PACIFIC GAS AND ELECTRIC COMPANY
DIABLO CANYON NUCLEAR POWER PLANT, UNIT 1
DOCKET NO. 50-275
AMENDMENT TO FACILITY OPERATING LICENSE

PACIFIC GAS AND ELECTRIC COMPANY
DIABLO CANYON NUCLEAR POWER PLANT, UNIT 2
DOCKET NO. 50-323
AMENDMENT TO FACILITY OPERATING LICENSE

ATTACHMENT TO LICENSE AMENDMENT NOS.12 AND 10
FACILITY OPERATING LICENSE NOS. DPR-80 AND DPR-82
DOCKET NOS. 50-275 AND 50-323

SAFETY EVALUATION BY THE OFFICE OF NUCLEAR REACTOR REGULATION
RELATED TO AMENDMENT NO. 12 TO FACILITY OPERATING LICENSE NO. DPR-80
AND AMENDMENT NO. 10 TO FACILITY OPERATING LICENSE NO. DPR-82
PACIFIC GAS AND ELECTRIC COMPANY
DIABLO CANYON NUCLEAR POWER PLANT, UNIT NOS. 1 AND 2
DOCKET NOS. 50-275 AND 50-323

FIGURE 3.2-1a

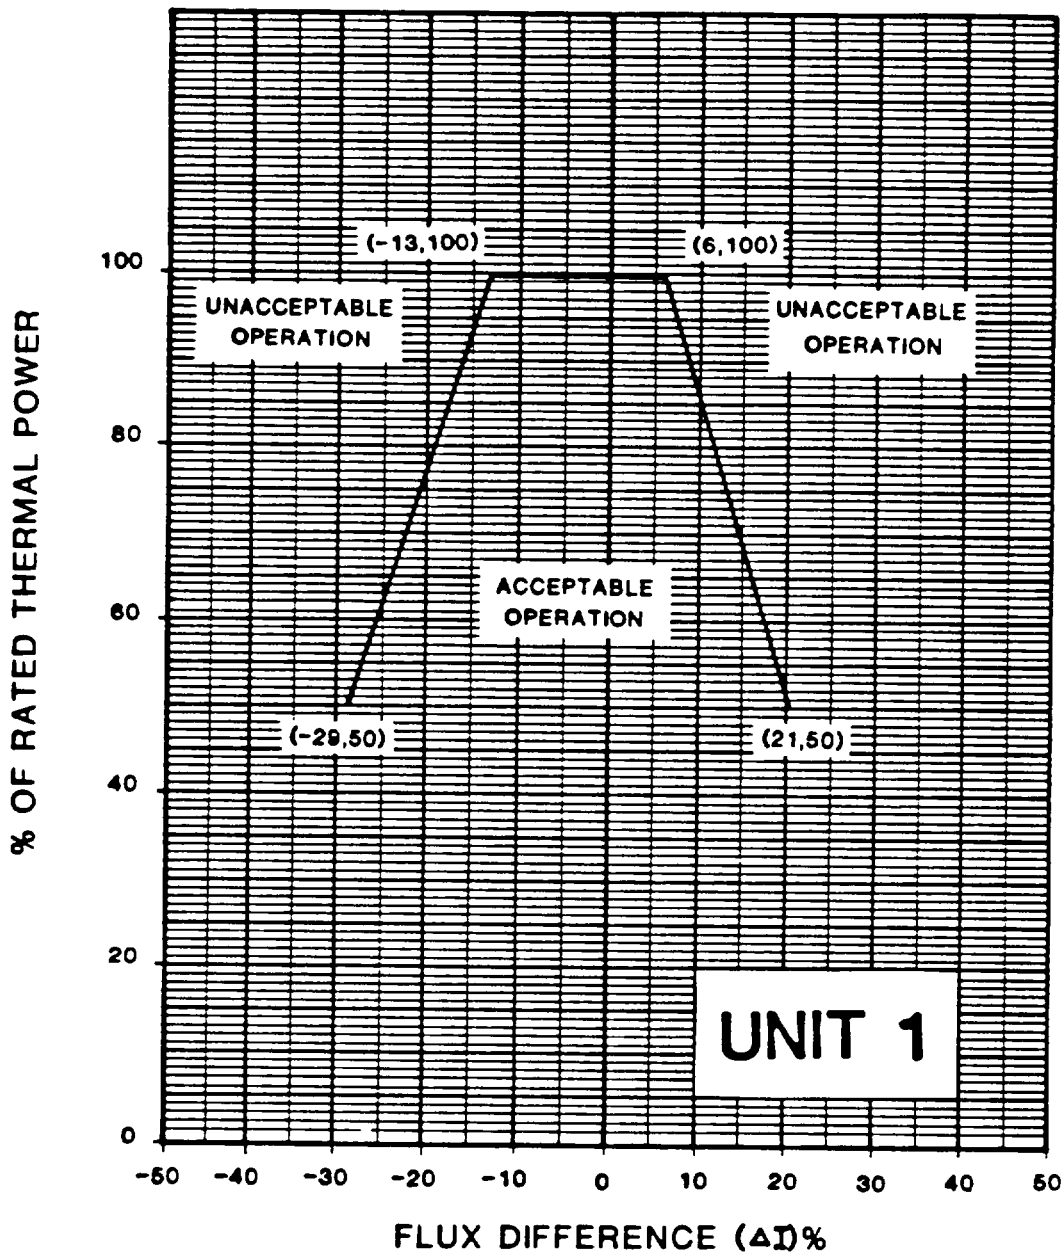
3.2.1 The indicated AXIAL FLUX DIFFERENCE (AFD) shall be maintained within the allowed operational space defined by Figure 3.2-1a for Unit 1, and Figure 3.2-1b for Unit 2.

- a. With the indicated AXIAL FLUX DIFFERENCE outside of the Unit 1 Figure 3.2-1a limits or Unit 2 Figure 3.2-1b limits,
 1. Either restore the indicated AFD to within the Unit 1 Figure 3.2-1a or Unit 2 Figure 3.2-1b limits within 15 minutes, or
 2. Reduce THERMAL POWER to less than 50% of RATED THERMAL POWER within 30 minutes and reduce the Power Range Neutron Flux - High Trip setpoints to less than or equal to 55 percent of RATED THERMAL POWER within the next 4 hours.
- b. THERMAL POWER shall not be increased above 50% of RATED THERMAL POWER unless the indicated AFD is within the Unit 1 Figure 3.2-1a or Unit 2 Figure 3.2-1b limits.

FIGURE 3.2-1b

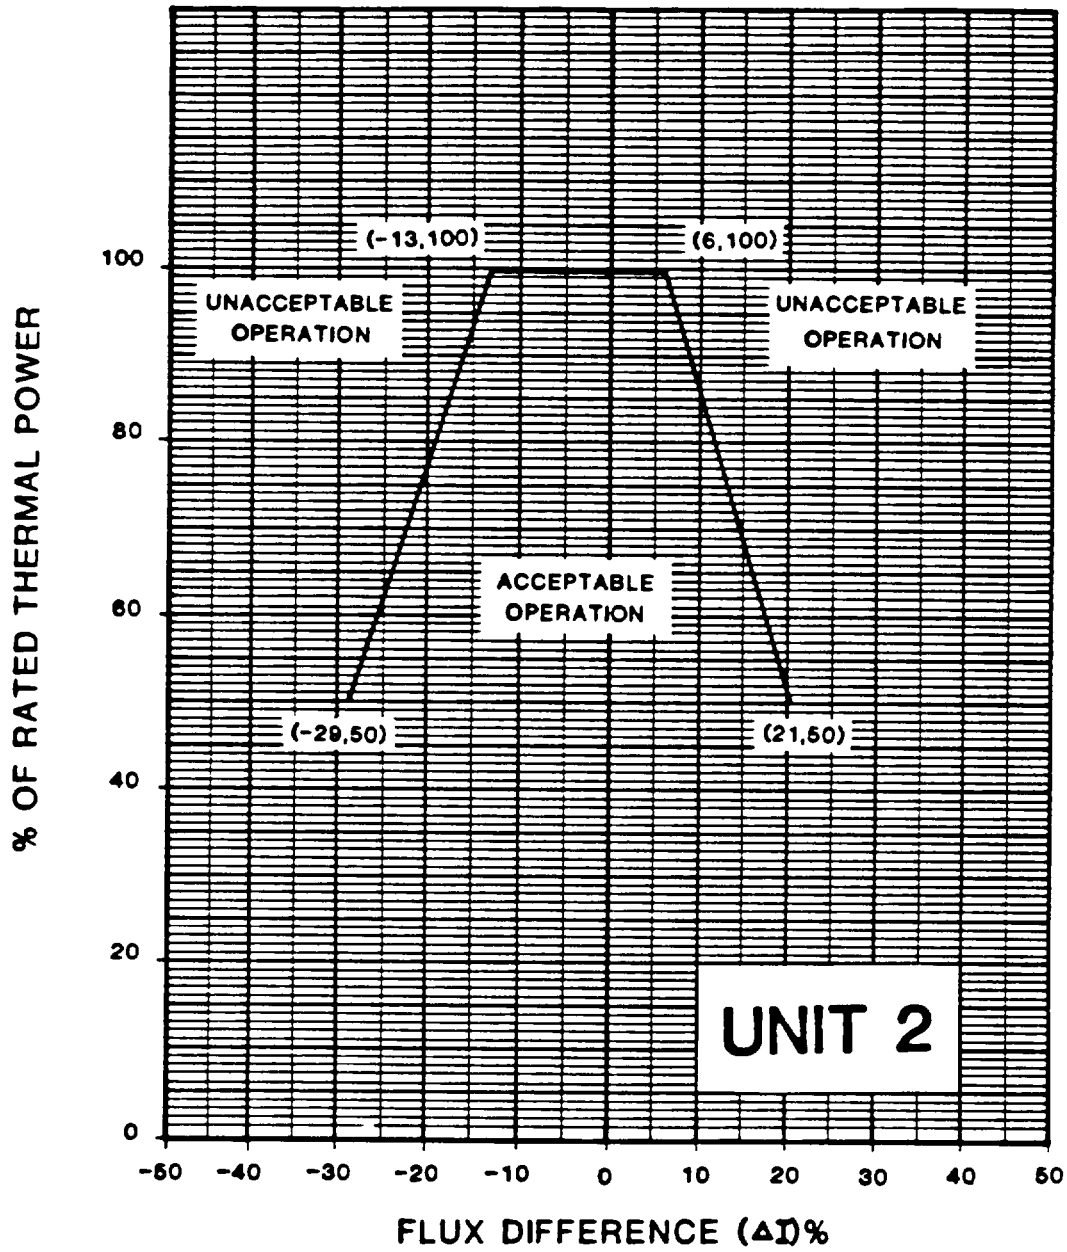
These amendments change the Technical Specifications, Section 3/4.2.1, "Axial Flux Difference", to implement for Unit 2 the Westinghouse developed relaxed axial offset control (RAOC) methodology after Unit 2 has reached a burn up of 8000 MWD/MTU in the first cycle.

The staff has reviewed the Technical Specification changes proposed by the licensee for Diablo Canyon Unit 2 and finds they correctly implement RAOC. The staff has previously approved identical implementation of RAOC for Diablo Canyon Unit 1 in Amendment 3 to Facility Operating License DPR-80 (Ref. 2). The staff, therefore, finds the proposed Technical Specification changes acceptable for Unit 2. The analysis described by the licensee applying RAOC to Diablo Canyon Unit 2 is applicable only after the unit reaches 8000 MWD/MTU burnup in Cycle 1 and thereafter until the end of Cycle 1. Cycle specific evaluations will be made by Westinghouse to determine if the allowable ΔI band curve will remain valid or require revision by further Technical Specification change.
